# Mira Mesa Community Plan Update

## Final Program Environmental Impact Report

### Errata

SCH No. 2022090061  
December 5, 2022

FIGURE 3-3

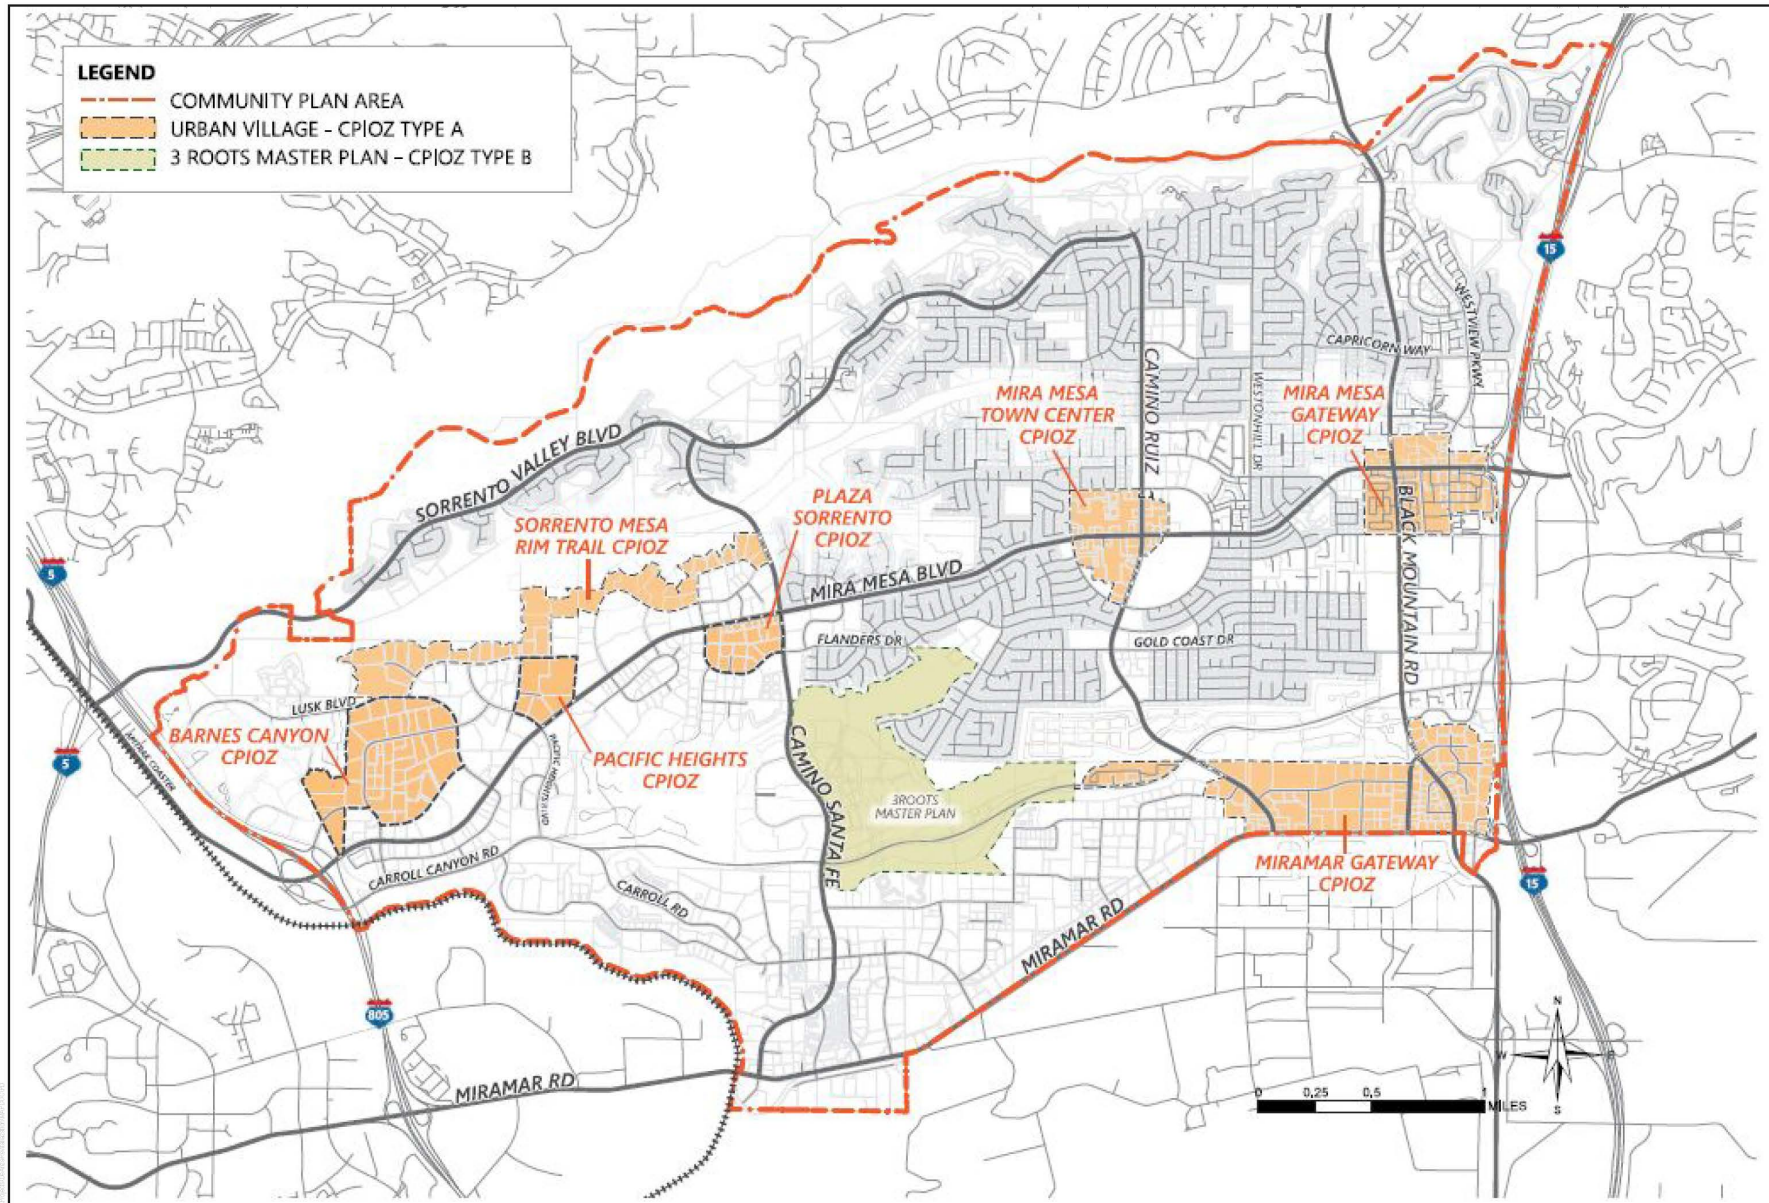
5. Chapter 3.0 Project Description, Figure 3-3, page 3-29, has been replaced with this image:

FIGURE 3-6

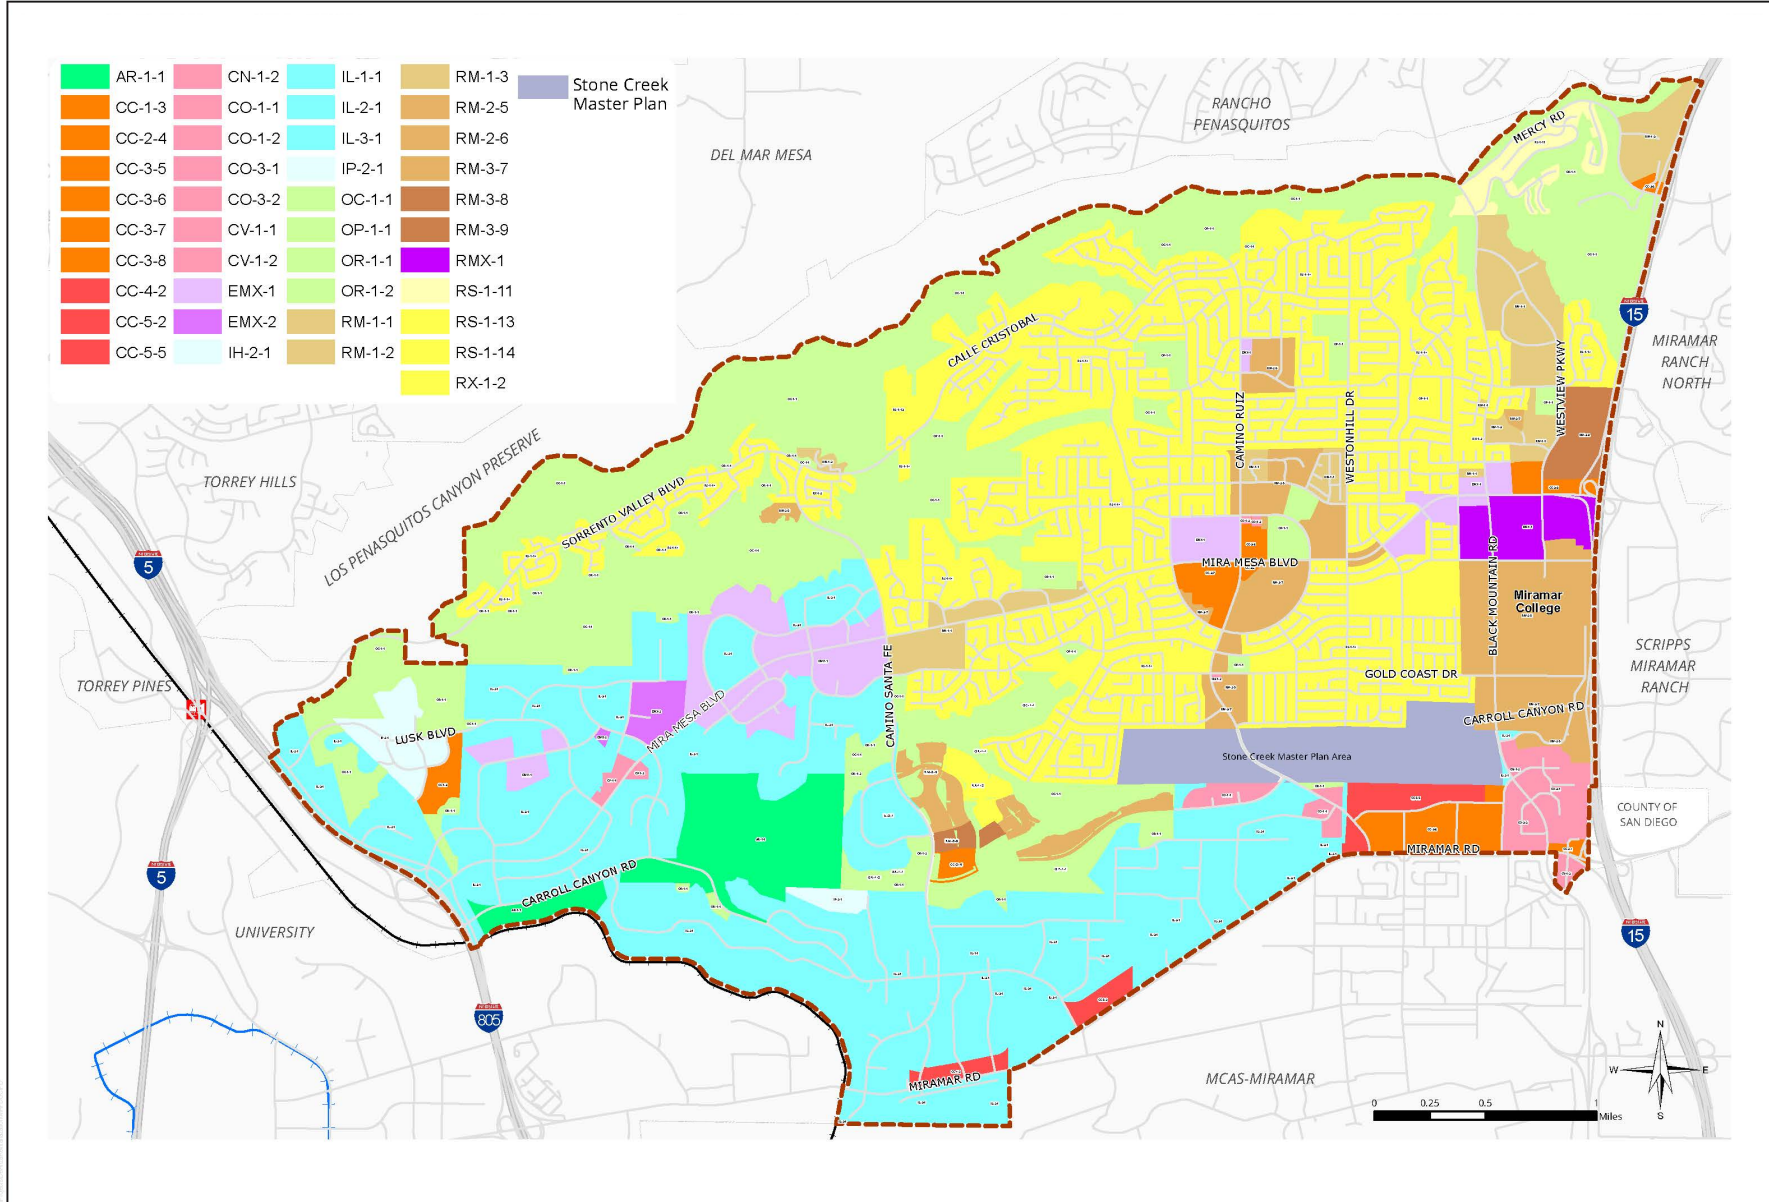
6. Chapter 3.0 Project Description, Figure 3-6, Proposed Zoning, on page 3-36, has been replaced with this image:
